Sundry Print Report

Well Name: WEST BISTI COAL 13	Well Location: T25N / R13W / SEC 13 / NWNW / 36.405006 / 108.175369	County or Parish/State: SAN JUAN / NM
Well Number: 2T	Type of Well: OTHER	Allottee or Tribe Name:
Lease Number: NMNM33917	Unit or CA Name:	Unit or CA Number:
US Well Number: 3004533136	Well Status: Gas Well Shut In	Operator: DJR OPERATING LLC

Type of Submission: Notice of Intent**Type of Action** Plug and Abandonment**Date Sundry Submitted:** 01/27/2021**Time Sundry Submitted:** 09:23**Date proposed operation will begin:** 01/27/2021

Plug and Abandonment Procedure
for
DJR Operating, LLC
West Bisti Coal 13 2T
API # 30-045-33136
NW/NW, Unit D, Sec. 13, T25N, R13W
San Juan County, NM

DJR Operating, LLC
Proposed Wellbore Diagram

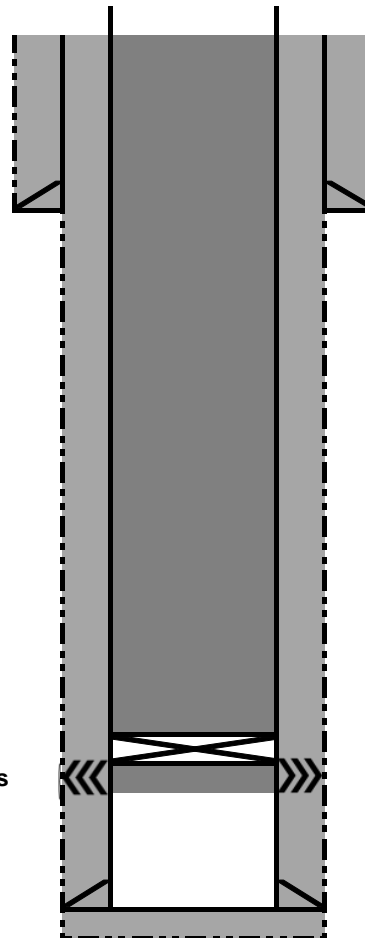
- BLM formation top estimate for the Ojo Alamo formation varies from operator pick. No change to the P&A procedure is required (entire well bore will be cemented to surface).
- Log analysis of reference well #2 indicates the Nacimiento and Ojo Alamo sands investigated likely contain fresh water ($\leq 5,000$ ppm TDS). P&A procedure has cement from the cement retainer @ 1280' to Surface which will protect freshwater sands in this well bore.
- Fruitland Coal perforations @ 1317'-1364'.
